LEICESTERSHIRE COUNTY COUNCIL

NORTH AND EAST MELTON MOWBRAY DISTRIBUTOR ROAD

Response to Mr G. Brooker (DfTObj03)

September 2021

Figure 1 Lag Lane, Thorpe Arnold - Highway Extents

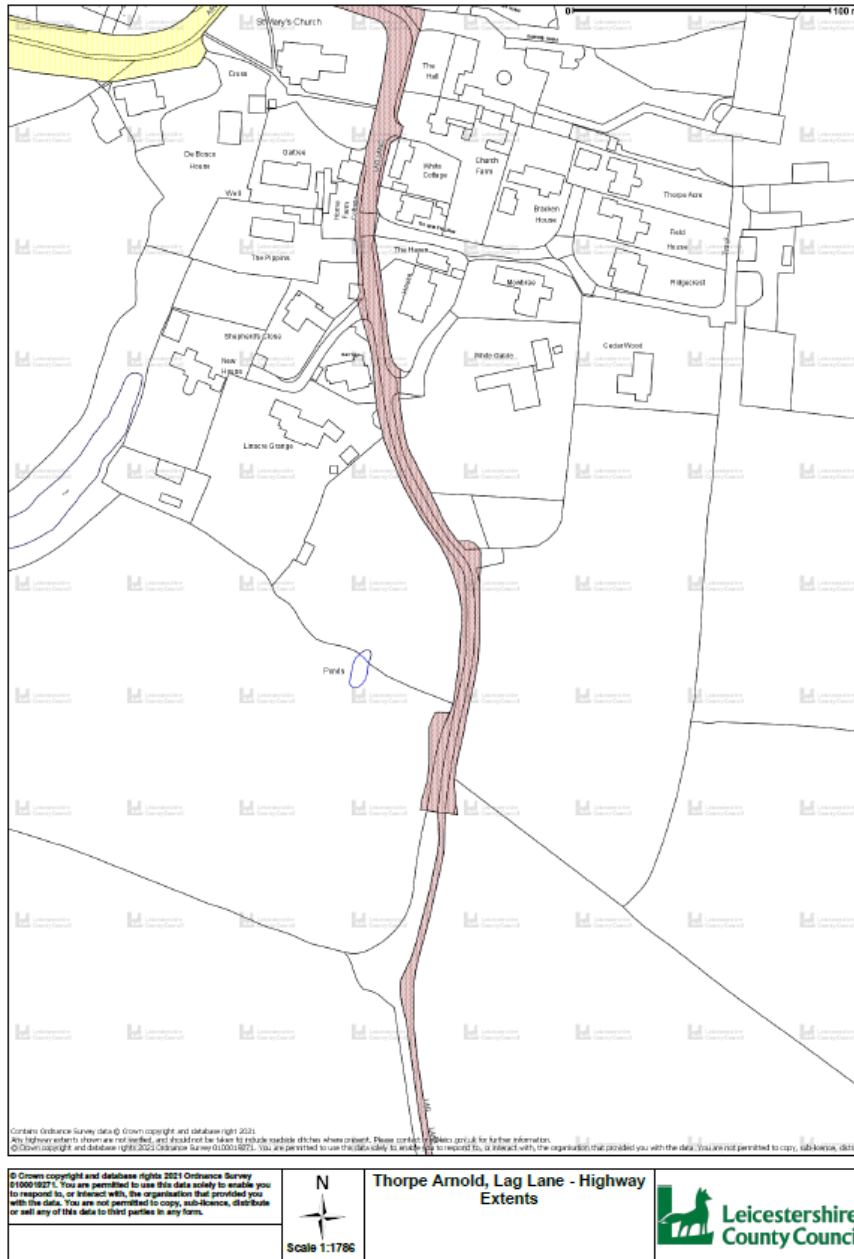
2.9.2. Finally, the Council would wish to draw attention to the limits of the highway as exist for Lag Lane. Mr Brooker has presented a coloured plan with the extent of Lag Lane shown coloured green. An extract from the official County Council plan showing the limits of Lag Lane coloured brown is shown in Figure 1. It can be demonstrated the extent of the highway extends beyond the areas shown by Mr Brooker and in fact it would appear that some areas on the ground along Lag Lane have been excluded from the highway as shown.
